ATTACHMENT 3A

Emergency Plan Marked-up Pages – Clinton Station

Exelon Standardized Emergency Plan EP-AA-1000
and
Emergency Plan Annex EP-AA-1003

Figure B-1a: Exelon Overall ERO Command Structure

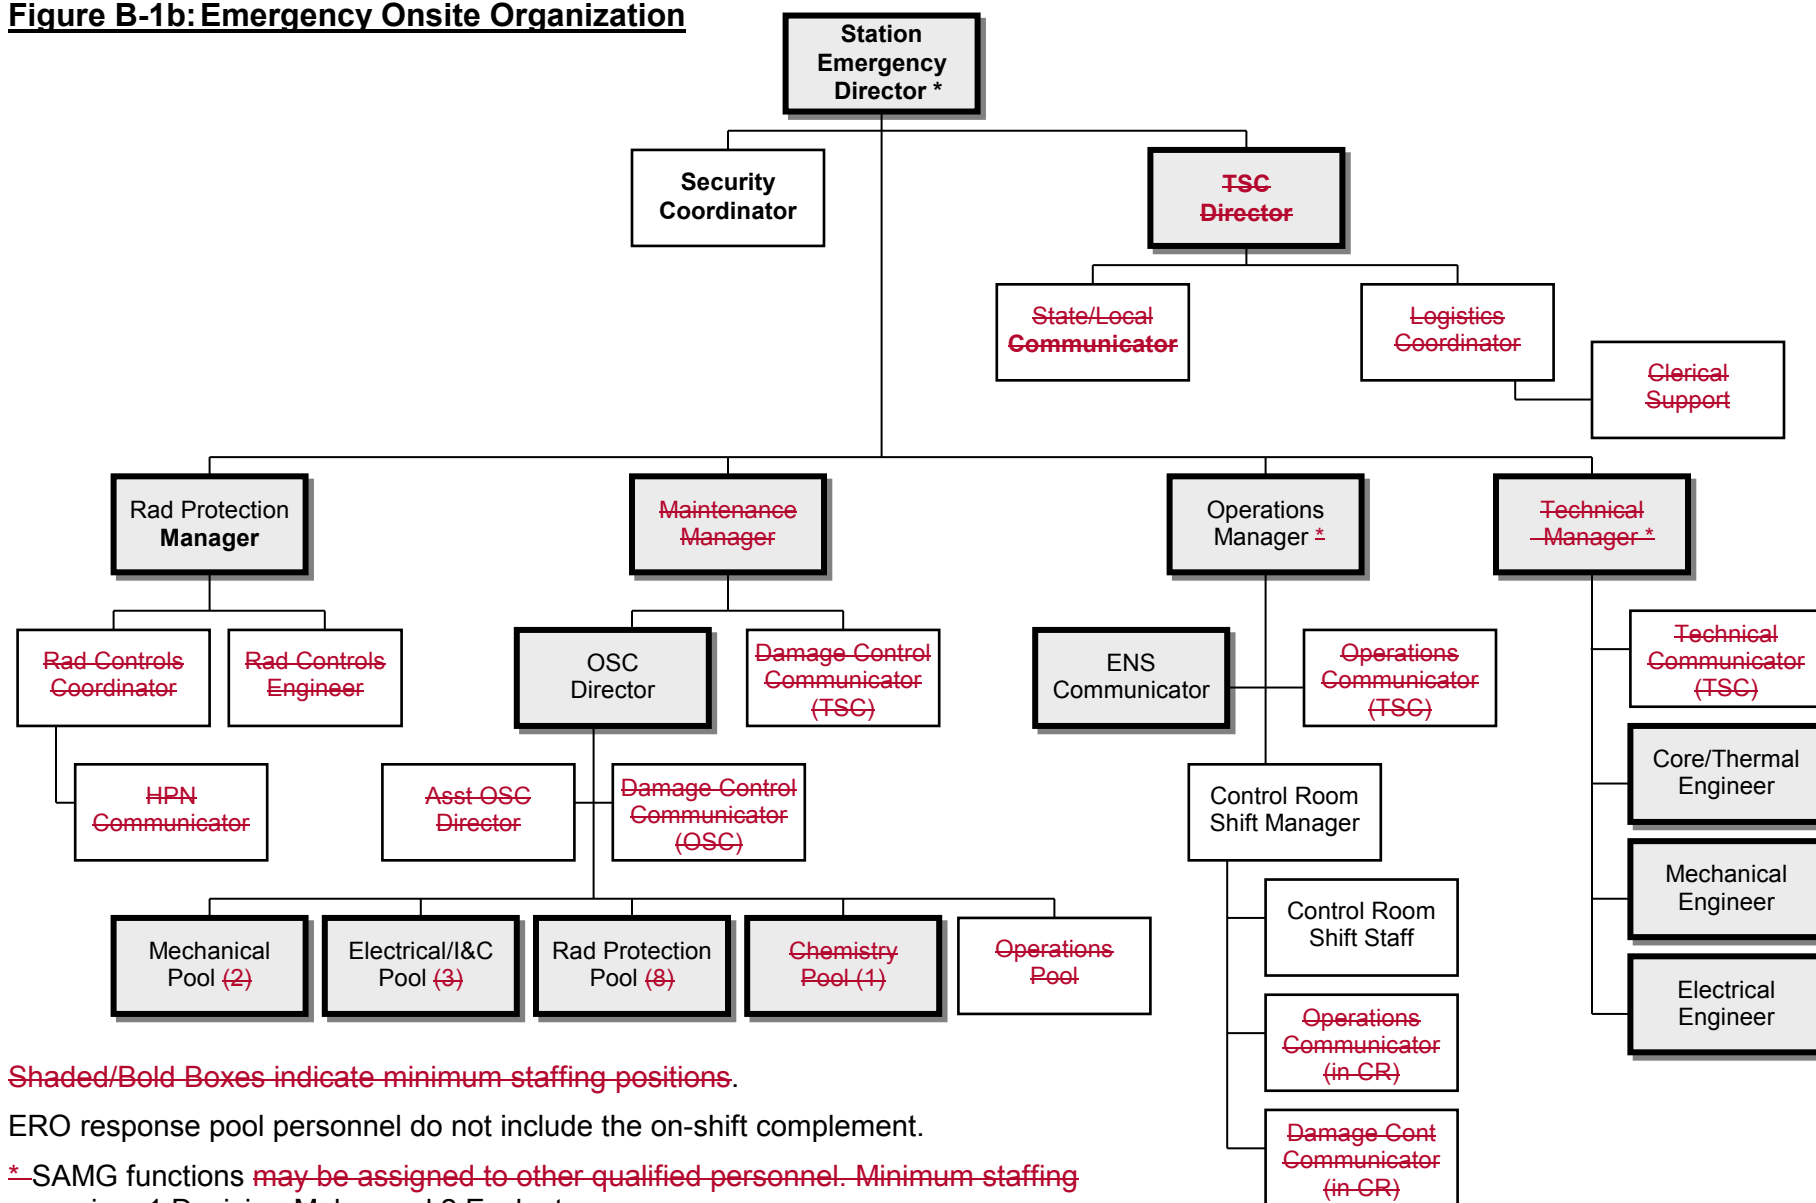
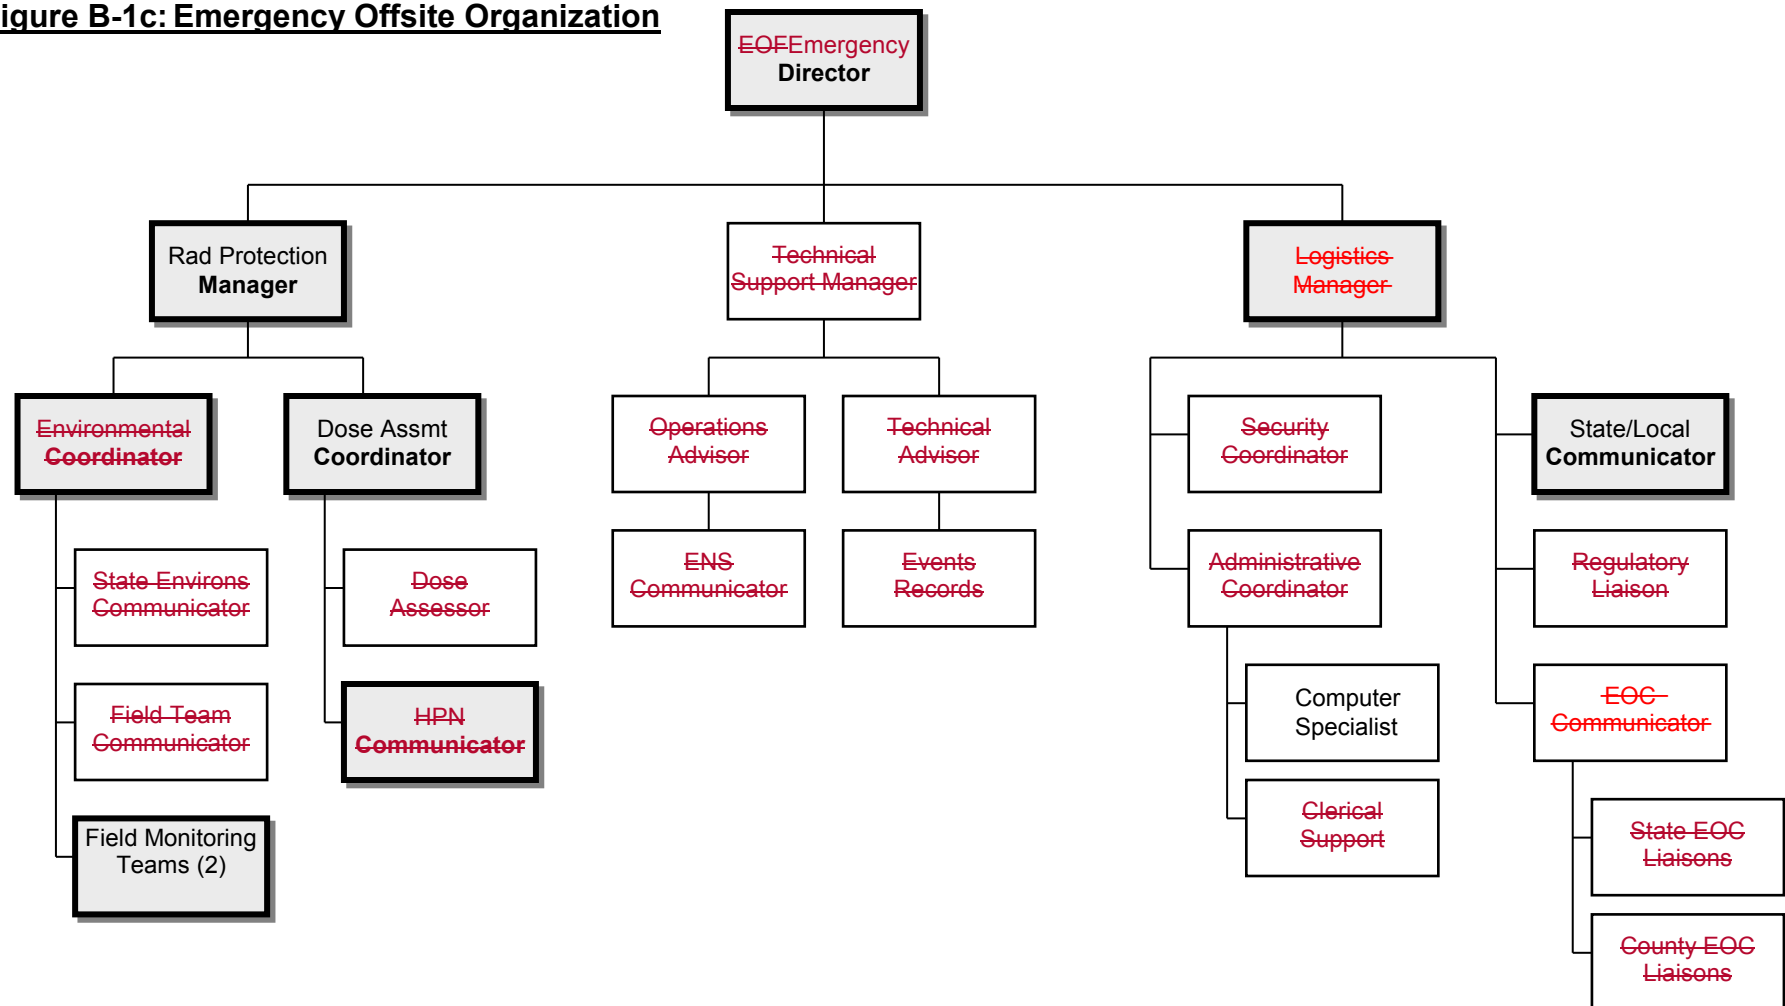
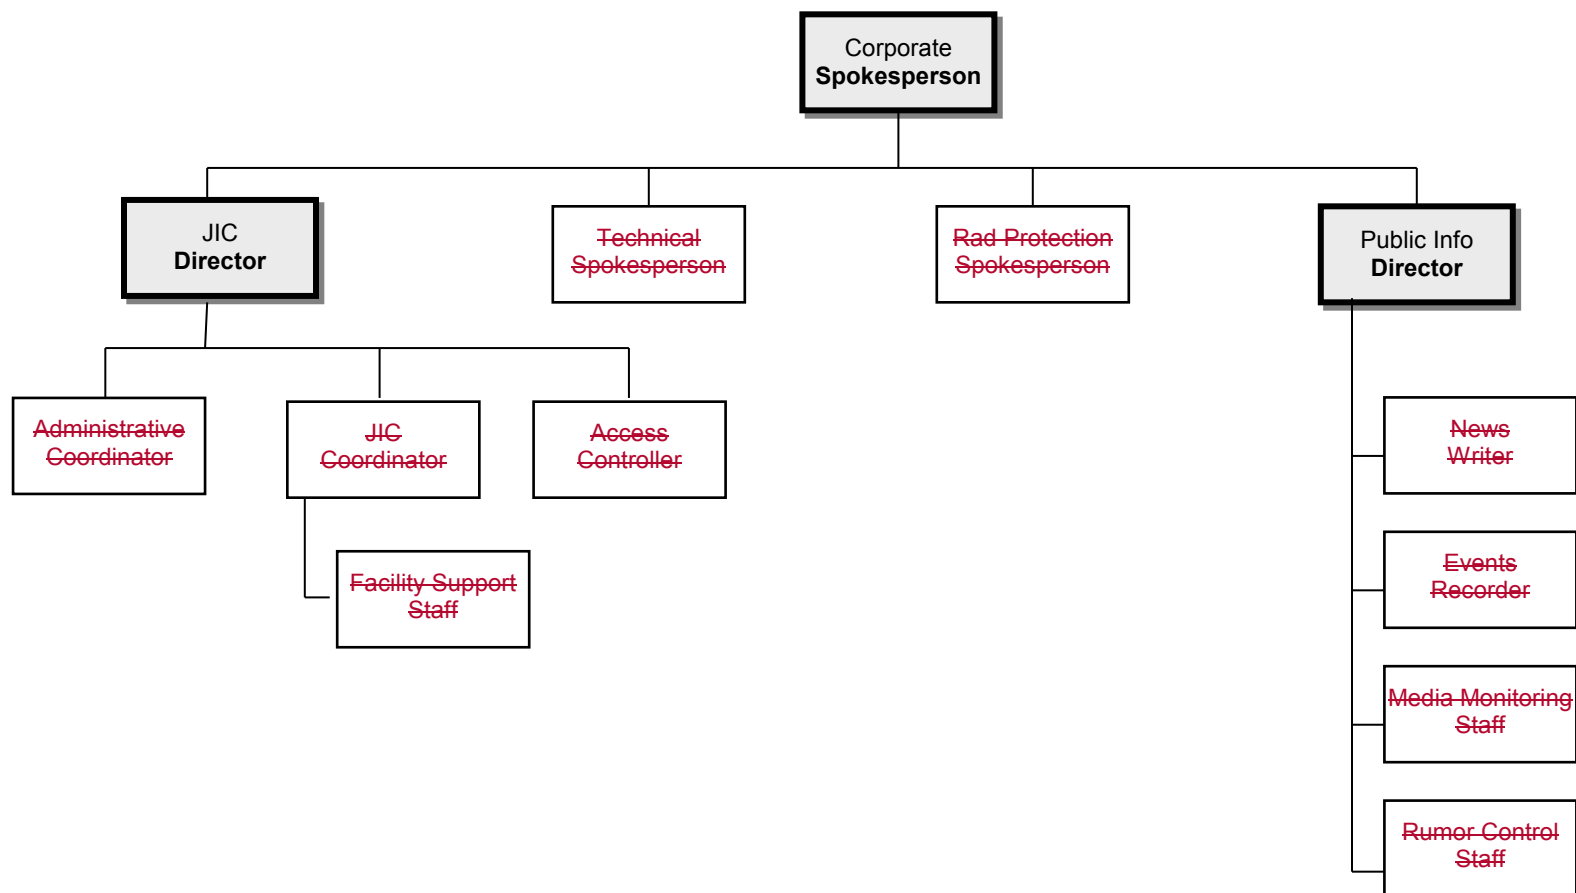
ERO staffing tables contained ~~within the station specific Annexin Appendix 5,~~ lists the key positions of the ERO ~~and the supporting positions assigned to interface with federal, state, and county authorities.~~ Figures B-1a through B-1d illustrates the overall emergency response organization. Section B.5 discusses specific responsibilities and the interrelationships for key positions.
